**STAFF RECOMMENDATION**  
**2116 Pontotoc Avenue**  
**August 17, 2016**

**Application:** New construction – rear addition  
**District:** Eastwood Neighborhood Conservation Zoning Overlay  
**Council District:** 06  
**Map and Parcel Number:** 08303008200  
**Applicant:** Jeff Kendig, Owner  
**Project Lead:** Sean Alexander, sean.alexander@nashville.gov

2116 Pontotoc Avenue  
Site Plan  
Proposed Addition

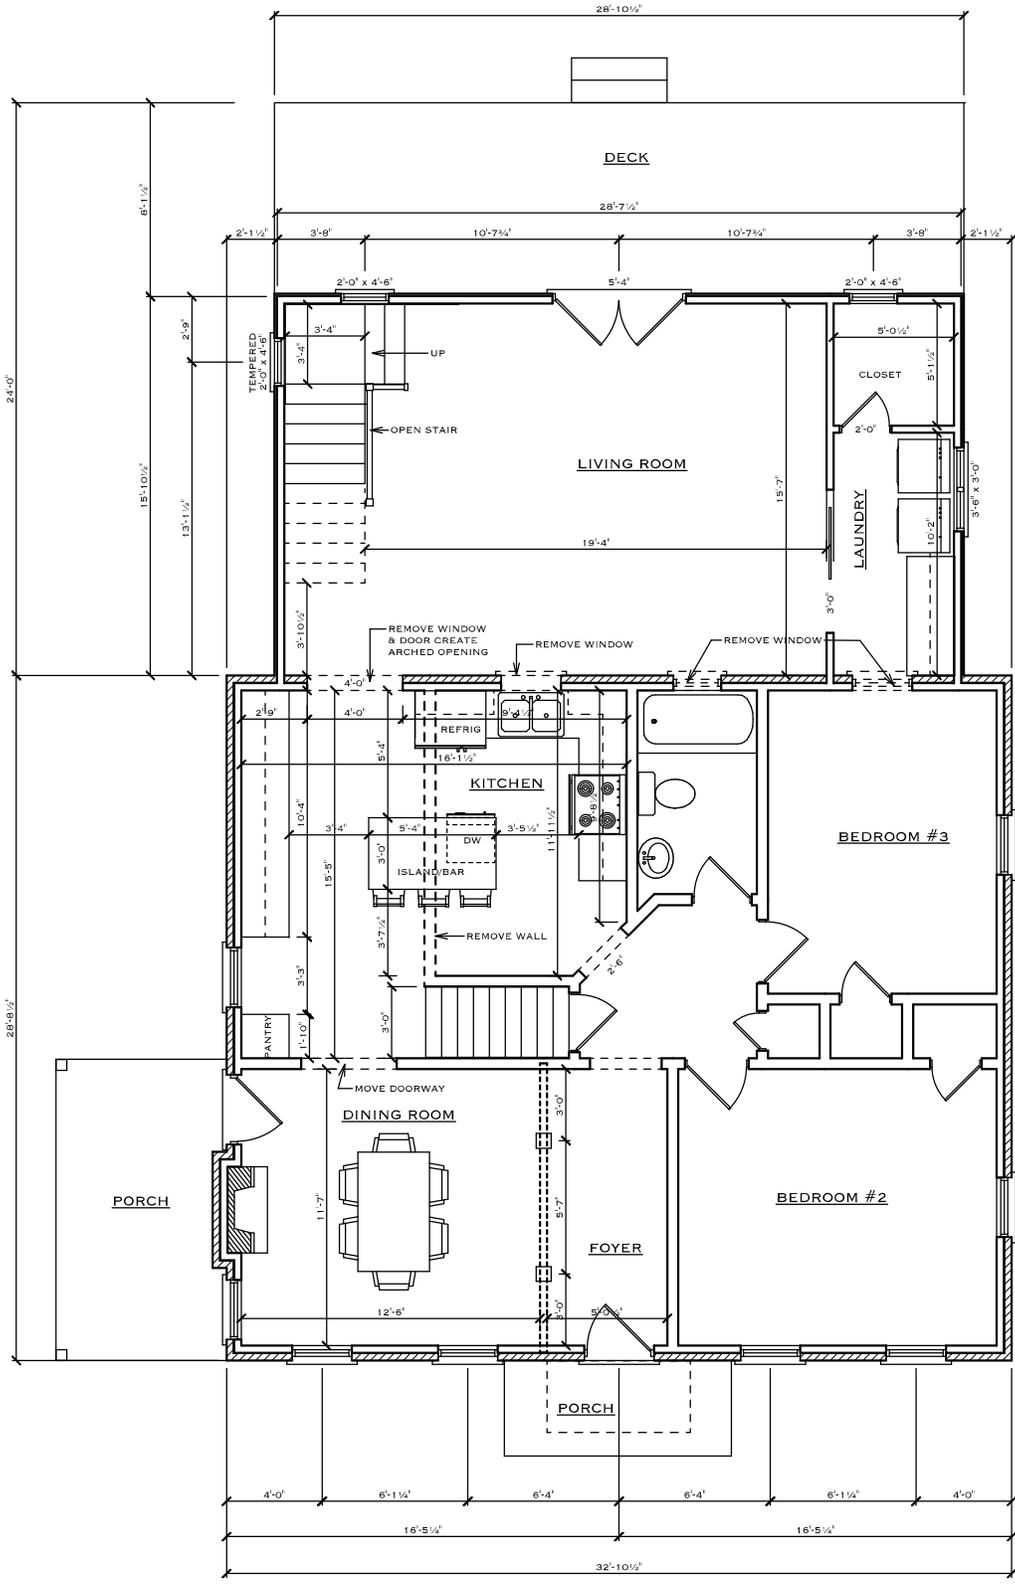
Setback & Rhythm of Spacing: The addition is stepped in two feet (2') from the sides of the house, therefore it does not impact the form or silhouette and will have greater setbacks than the existing building on both sides. The left side setback will be thirteen feet, six inches (13'-6") from the property line and the right side will be nine feet (9'). These setbacks would be appropriate generally but because the lot is an irregular shape and on a corner lot with a collector street along the side, standard zoning and codes requires a twenty foot (20') setback from Porter Road. Staff finds that the proposed addition is compatible with the historic house and that the project meets section II.B.1.c of the design guidelines as submitted.

**Recommendation:** Staff recommends approval of the proposed ridge-raise and rear addition, with the setbacks as submitted, with the conditions that the window and door selections shall be approved by staff. With that condition met, Staff finds that the proposal meets the design guidelines for the Eastwood Neighborhood Conservation Zoning Overlay.

FIRST FLOOR PLAN

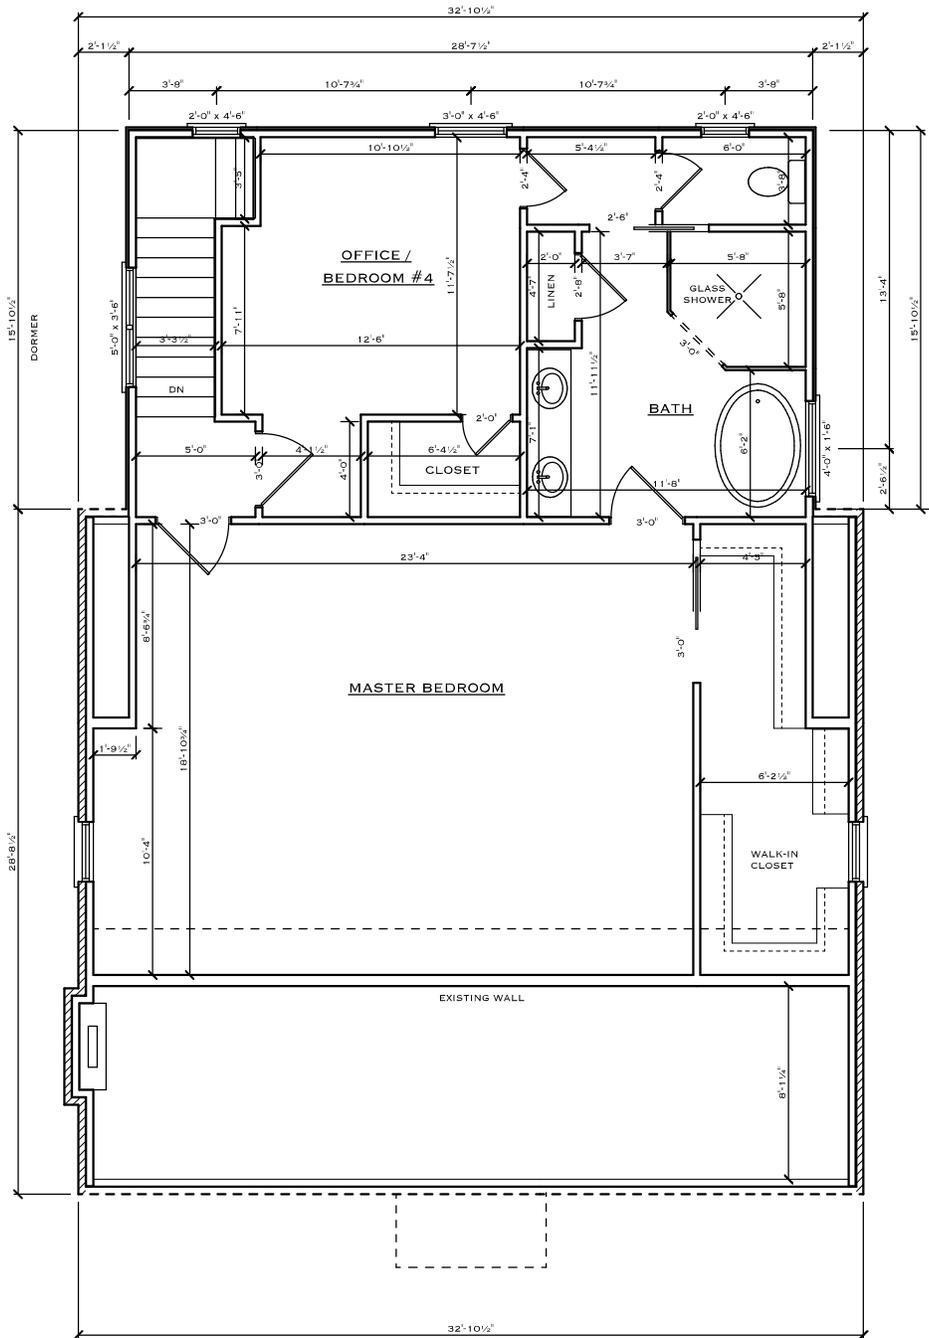
Location & Removability: The front slope of the roof will be extended up and to the back, increasing the ridge height by two feet. The ridge-raise addition will step in two feet (2') from the sides of the existing house's walls and eaves, and the new ridge will extend to the rear with an addition that also steps in two feet from the sides of the house. The addition will extend sixteen feet (16') to the rear, which is approximately half the depth of the original house.

Roof form: The front slope of the house will be extending up and back, maintaining the existing 8:12 pitch. From the new ridge the roof will shed over the addition with a pitch of 1:12. The side gable form will be retained, with the eaves and two feet (2') of the existing ridge on each side unaltered. A gabled roof supported by brackets will also be added over the front door. Whereas adding a full porch would not be appropriate, the Commission has previously found small protective covering over entrances to be appropriate when they are minimal and not supported by columns. This gabled hood will be only five feet (5') wide and project three feet (3'), with a pitch matching the primary roof. Staff finds the front hood, ridge-raise and shed roofs to be compatible with the historic house and to meet section II.B.1.e of the design guidelines.

Proportion and Rhythm of Openings: A side-facing window near the rear of the house in a porch that has already been enclosed will be removed and the space filled in with siding, but no other changes to the window and door openings on the existing house were indicated on the plans. The windows on the proposed addition are all generally twice as tall as they are wide with the exception of a transom-like window on the right side. This window will be obscured by the eaves of the house and will not be greatly visible from the street. There are no large expanses of wall space without a window or door opening.
